Access Compliance Report Public Rights-of-Way (Curb Ramps)

Intersection ID: 44221 Main Street: ATHERTON MILL RD Cross Street: RICHARD ROZZELLE DR Location: NW **ADA ID: 26E12A72C7CD** Ramp Type: PerpDiag Initial Pass/Fail: Fail **Overall Compliance: No Severity Score:** 25

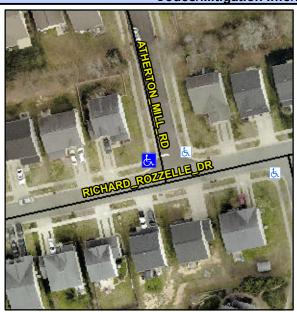
Field Measurements/Component Compliance					
Compliance Description		Data	Comp	liance Description	Data
N/A	Ramp Length (in)	74.5	Yes	Ramp Slope (%)	5.3
Yes	Ramp Width (in)	48.0	No	Ramp XSlope (%)	9.2
N/A	Flare Type LT	N/A	N/A	Flare Type RT	N/A
N/A	Flare Slope LT (%)	N/A	N/A	Flare Slope RT (%)	N/A
N/A	Flare Traversable LT?	N/A	N/A	Flare Traversable RT?	N/A
N/A	Landing Length (in)	N/A	N/A	DWS Provided?	N/A
N/A	Landing Width (in)	N/A	N/A	DWS Contrast?	N/A
N/A	Landing Slope (%)	N/A	N/A	DWS Length (in)	N/A
N/A	Landing X Slope (%)	N/A	N/A	DWS Full Width?	N/A
N/A	Landing Curb? (Y/N)	N/A	N/A	DWS Offset (in)	N/A
N/A	Shared Landing?	N/A			
N/A	Gutter Ponding?	N/A	N/A	Gutter Slope (%)	N/A
N/A	Gutter Lip Ht (in)	N/A	N/A	Gutter X Slope (%)	N/A
N/A	Painted X Walk1?	No	N/A	Painted X Walk2?	No
	X Walk 1 Direction	To S		X Walk 2 Direction	To E
N/A	X Walk 1 Width (in)	N/A	N/A	X Walk 2 Width (in)	N/A
	X Walk 1 Slope (%)	6.4		X Walk 2 Slope (%)	1.4

Possible Solutions: Remove & Replace Curb Ramp With **Two New Directional Ramps or** Equivalent. Surveyor Notes: N/A PROW/ADA: R304.5.3
